RE: LFPCN41229

**Subject: LFPCN41229- Alternative Assembly Location Approval**

## Product/Process Change Notice (PCN)

## Product Qualification Report

## 1.2. Marking change

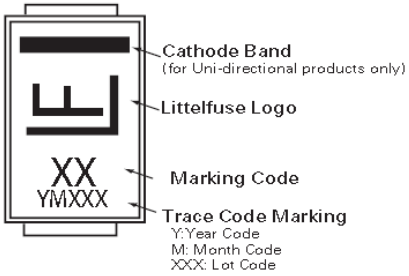
Will change the trace code marking from YMXXX to YM6XX and number 6 is the outsource code.

## 2. Process change

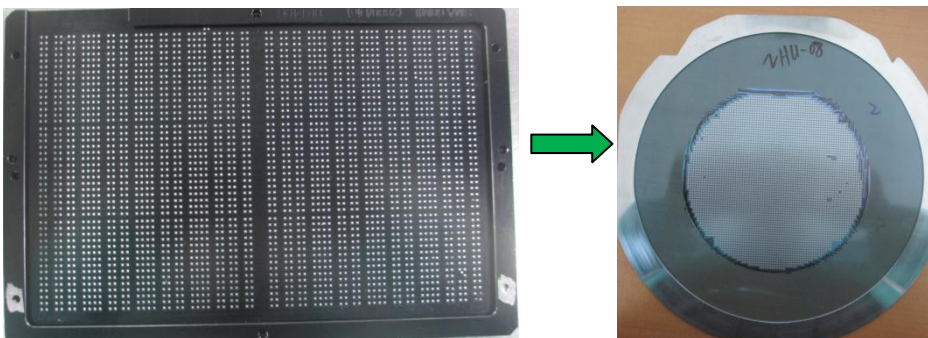
Process	Littelfuse	Outsource
Dicing	None tape	Blue tape cutting
Soldering	Manual soldering boat	Die-bonding
Molding	Molding profile for Littelfuse epoxy	Molding profile for outsource epoxy
Trim form	Trim form per Littelfuse process	Trim form per goodark process
Plating	Barrel plating	Rack plating
Test	per Littelfuse test spec and flow	per Littelfuse test spec and flow

2.1. The method loading method will be changed to adapt outsource process, so the dicing and soldering process is different

2.2. The outside plating in outsource is racking plating.

### 3. Packing

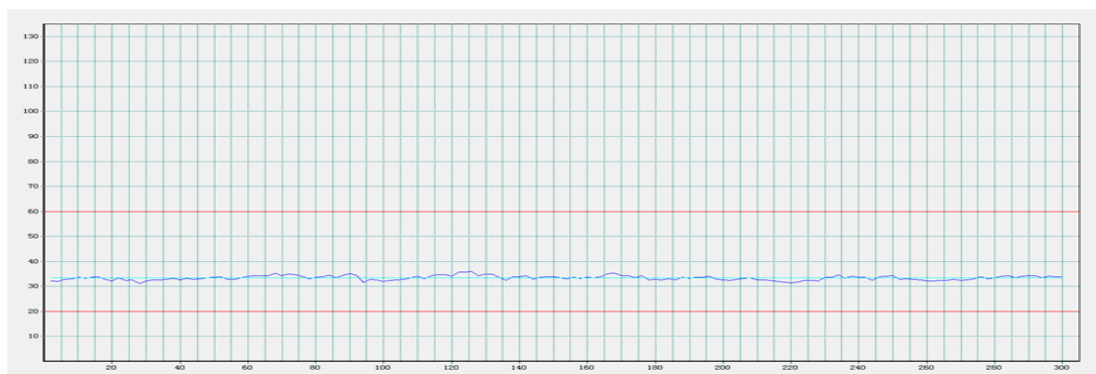
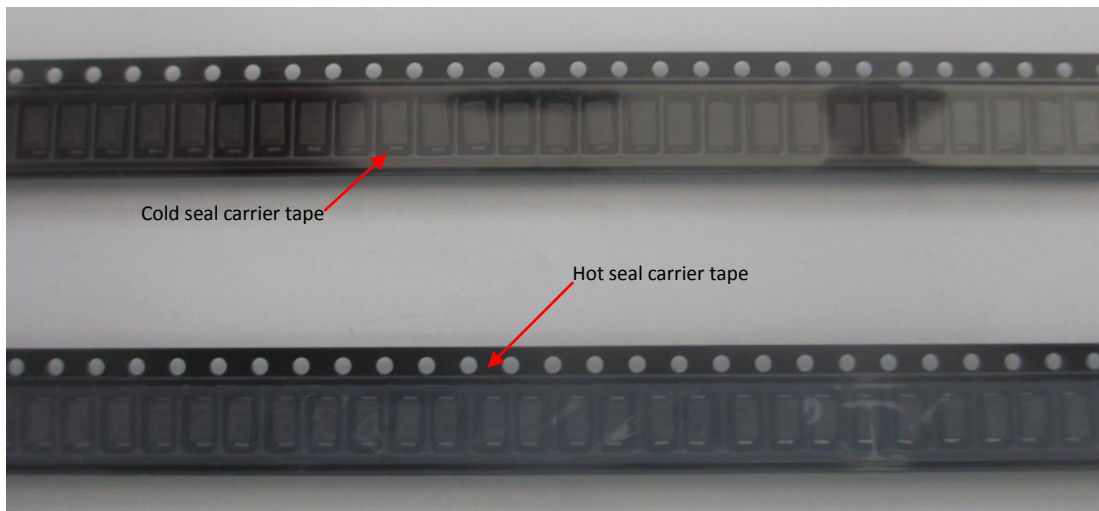
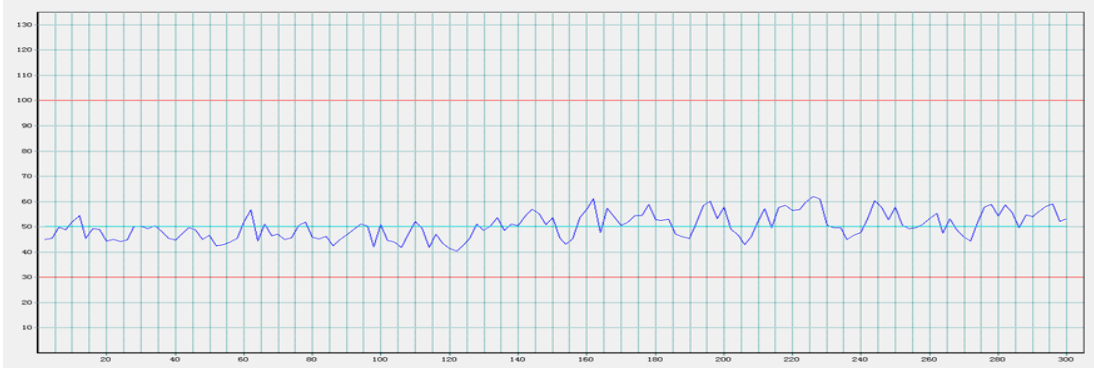
Packing	Littelfuse	Outsource
Tape	Cold seal carrier tape for SMA Hot seal carrier tape for SMB	Cold seal carrier tape for SMA&SMB
Reel	Littelfuse blue plastic tape, 13 inches	Outsource blue plastic tape, 13 inches
Internal pizza box	Per littelfuse	Per littelfuse
Label on pizza box	70mmx38mm, Front is internal font B, font size is 12 Bar code is code 128(B), height is 4.6mm	70mmx40mm, Front is Arial, font size is 12 Bar code is code 128(B), height is 4.57mm
Outside carton Box	Per Littelfuse	Per Littelfuse

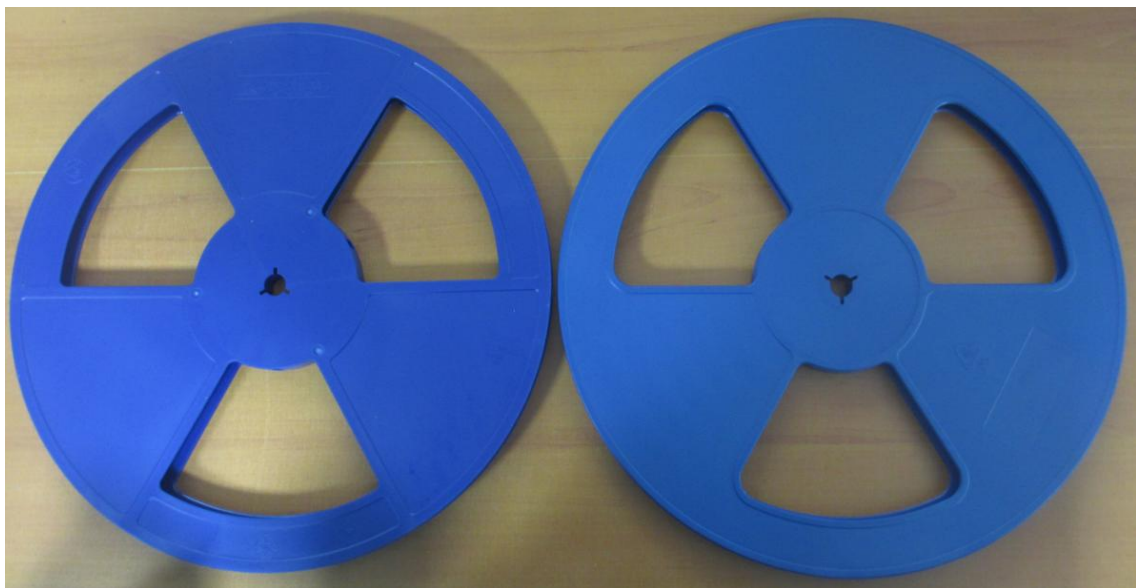
**3.1. The carrier pull force also change from 20~60g to 30~100g because Change SMA/DO-214AC series carrier tape to hot seal carrier tape.**

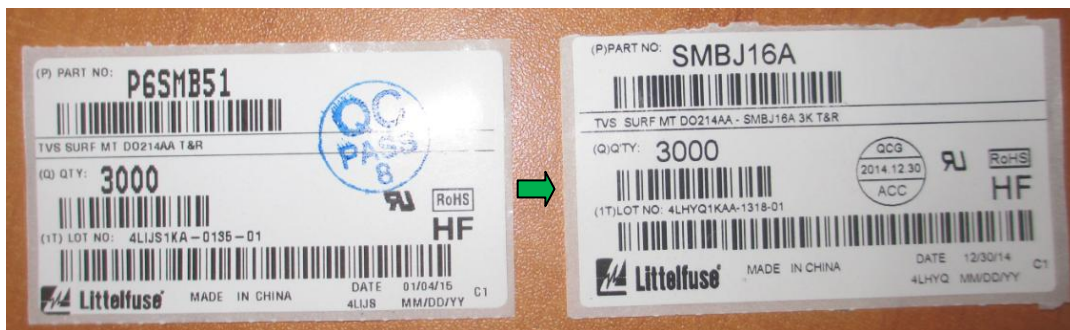
3.2. The blue plastic tape will change to outsource tape and the dimension will not change.
